AXC F 2152 – CHANGE NOTES

Change notes for the AXC F 2152 controller

Application note
108427_en_06

Current firmware version: 2019.0 LTS

Figure 1 Select Trigger task

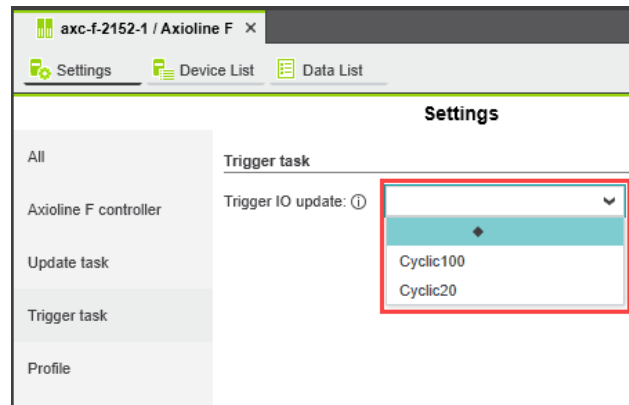
You can now specify the refresh interval for Axioline F I/O data. This is done by selecting which task triggers the Axioline F I/O data update in the PLCnext Engineer project.

- Double-click on the “Axioline F (x)” node in the “PLANT” area.

The “/ Axioline F” controller editor group opens.

- Select the “Trigger task” view in the “Settings” editor.
- In the drop-down list, select the task that is to trigger the Axioline F I/O data update.

If you do not select a task, the update will occur by default every 50 ms.
